ORIGINATION FORM

Proposed Revisions to a Standard Plans Index
(Please provide all information — Incomplete forms will be returned)

Index Number: 700-020
Sheet Number (s): 1, 2, & 3
Index Title: MULTI-COLUMN GROUND SIGN

MULTI-COLUMN GROUND SIGN

FRONT ELEVATION

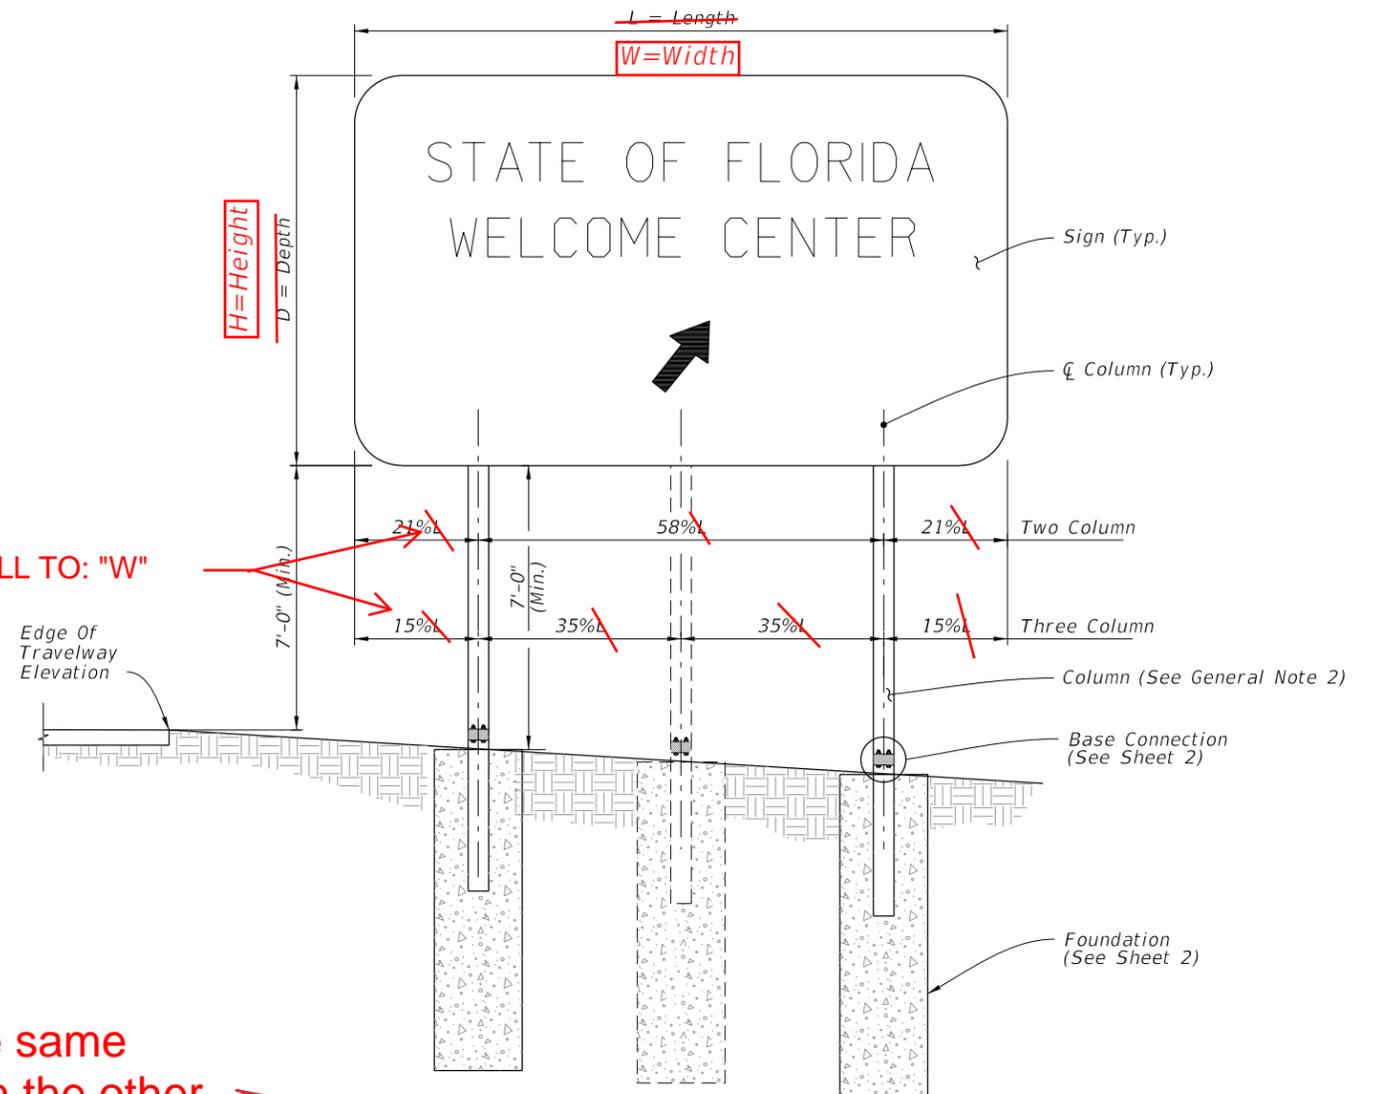
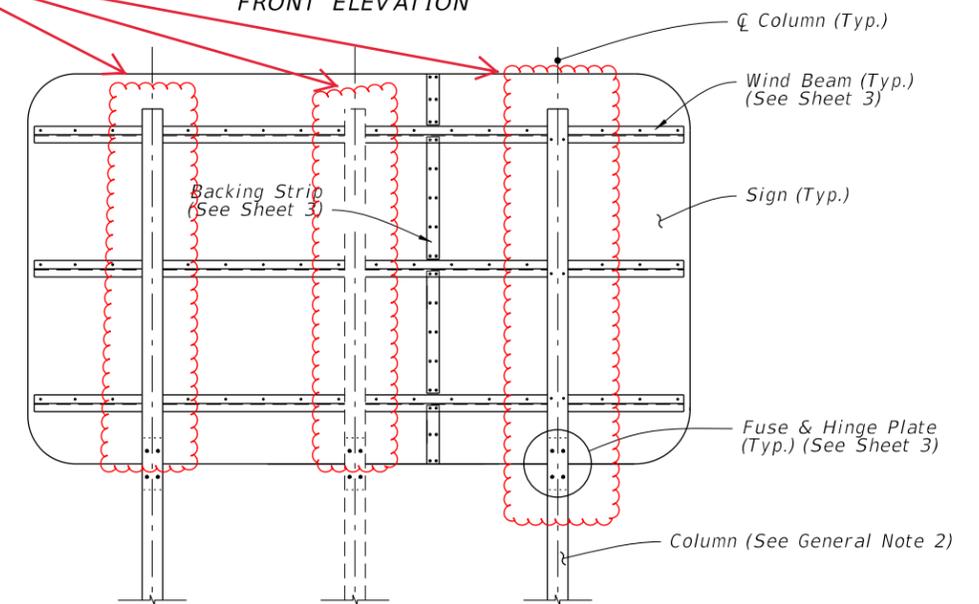
- Sheet 1: Revised bolts in the Hanger Beams to show correctly.
- Sheet 2: Added Foundation Notes to allow for precast concrete foundation with an octagon shape as a substitute for the circular shaped foundation shown.
- Sheet 3: Revised bolts in the Hanger Beams to show correctly.

- Sheets 1 & 3: The bolts were not showing correctly in the elevation details.
- Sheet 2: A non-circular, octagon shaft option was requested by industry to simplify formwork. (Revision by Richard Stepp)

On both sheets changed all reference of length to width and all reference to depth to height.

- A. Sign Support Shop drawings are not required when fabricated in accordance with this Index and support columns do not exceed the ~~length~~ ^{width} shown in the plans by more than 2'-0".
- B. Sign Panels: Horizontal panel splices are allowed at interior wind beams for sign panels with a ~~depth ("D")~~ ^{height ("H")} greater than 10 feet. Shop drawings required for horizontal panel splice details.
- C. ~~When~~ ^{Shop} drawings are required, obtain approval prior to fabrication.

CHANGE TO: height ("H")

CHANGED TO: width ("W")

CHANGED ALL TO: "W"

Show the same bolting on the other wind hanger beams

1. Meet the requirements of Specification 700.
2. Verify Column lengths in the field prior to fabrication.
3. Shop drawings:
 - A. Sign Support Shop drawings are not required when fabricated in accordance with this Index and support columns do not exceed the width ("W") shown in the plans by more than 2'-0".
 - B. Sign Panels: Horizontal panel splices are allowed at interior wind beams for sign panels with a height ("H") greater than 10 feet. Shop drawings required for horizontal panel splice details.
 - C. When shop drawings are required, obtain approval prior to fabrication.

FOUNDATION NOTES:

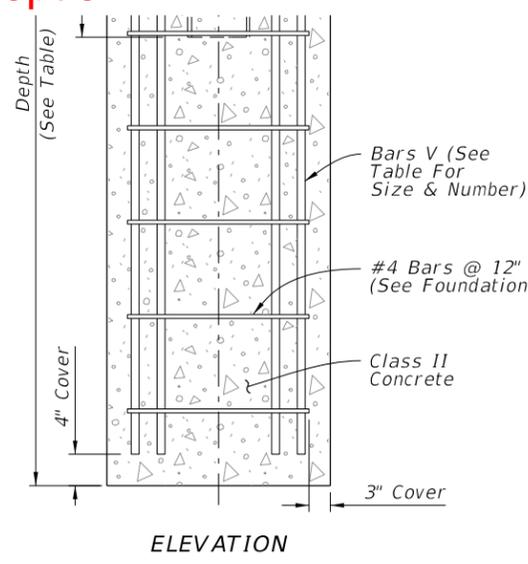
Revised note to add precast foundation option

Added note to explain the precast octagon shape option

The foundation may be either precast or cast-in-place. Use Reinforcing bars or equivalent Welded Wire Reinforcement.

For precast foundations, the circular cross section shown may be substituted with an octagon shape. The out-to-out distance between parallel edges must be greater than or equal to the diameter in the Foundation Data table. Use the same reinforcing diameter with centered placement and a minimum 3" cover.

MULTI-COLUMN SIGN ASSEMBLY

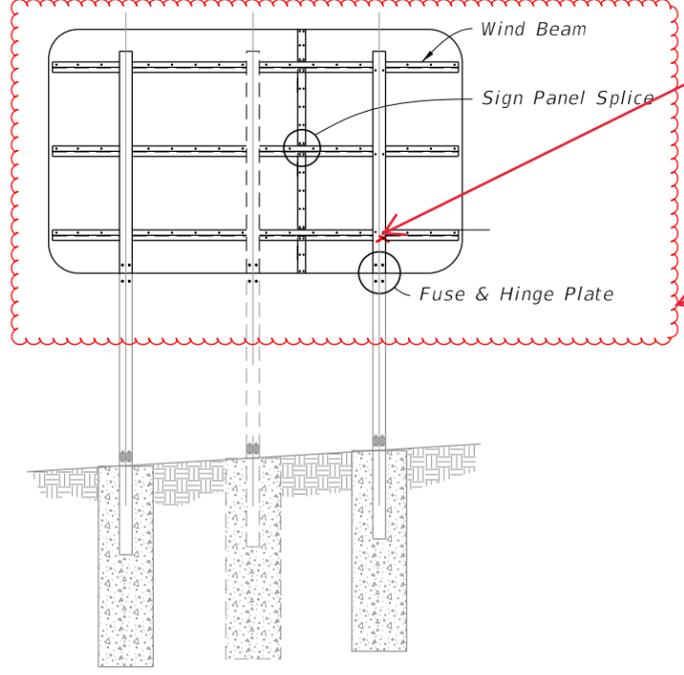
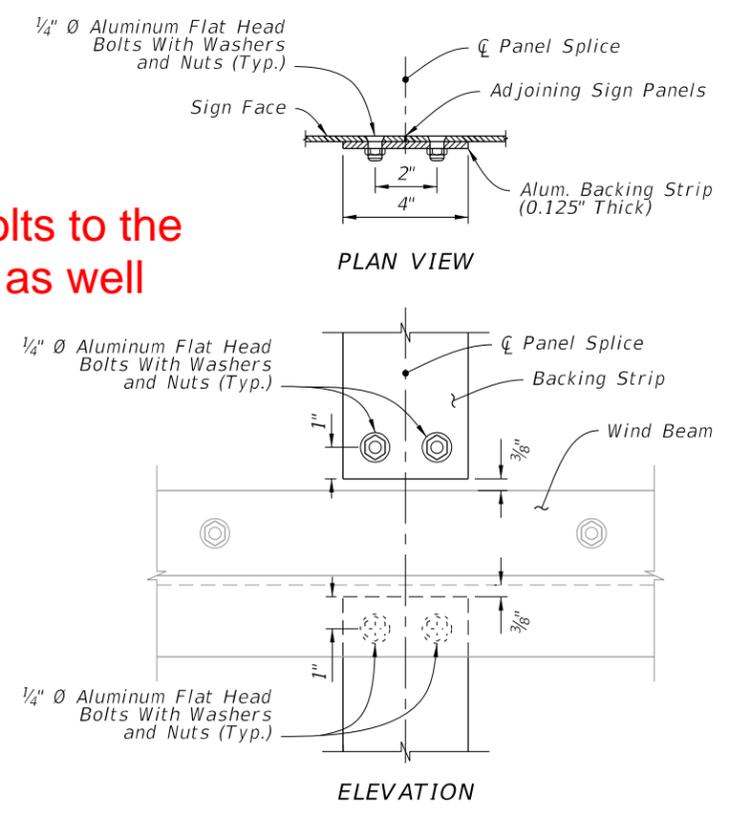
Only 2 bolts per intersection

Added the bolts to the other beams as well

BACK ELEVATION CHANGED TO: "H"

WIND BEAM, BACKING STRIP & FUSE/HINGE PLATE DETAILS

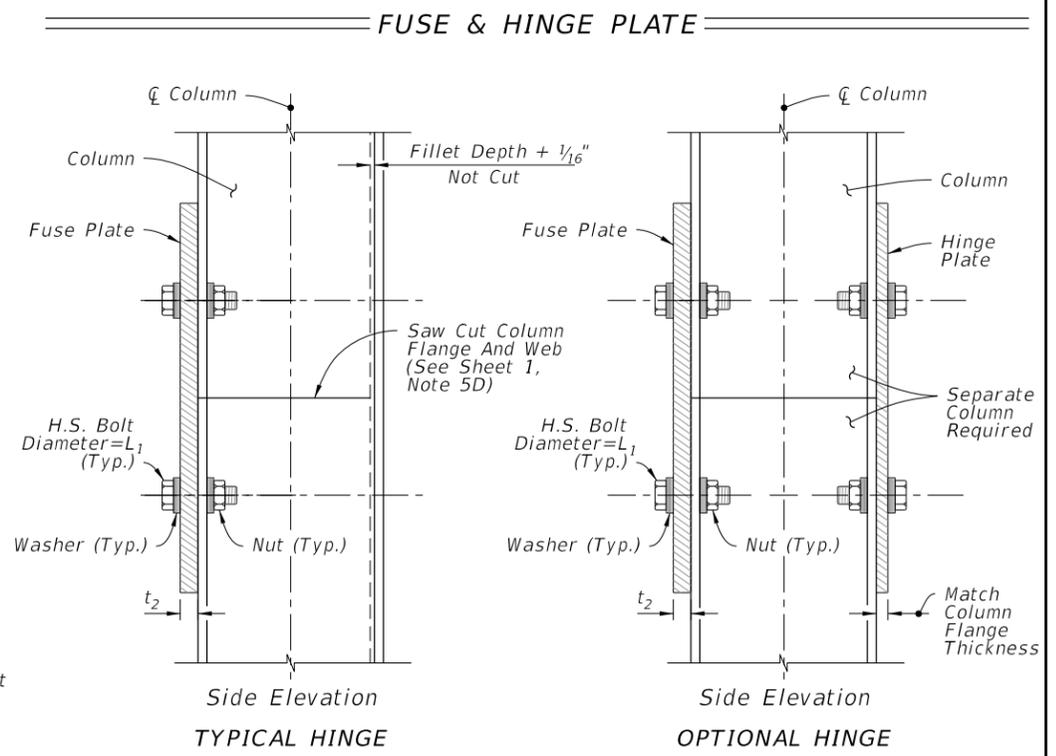
NUMBER OF WIND BEAMS BASED ON SIGN DEPTH (D)

WIND BEAM SIZE BASED ON SIGN LENGTH (L)

CHANGED TO: "W"

NUMBER OF WIND BEAMS BASED ON SIGN HEIGHT (H)

WIND BEAM SIZE BASED ON SIGN WIDTH (W)
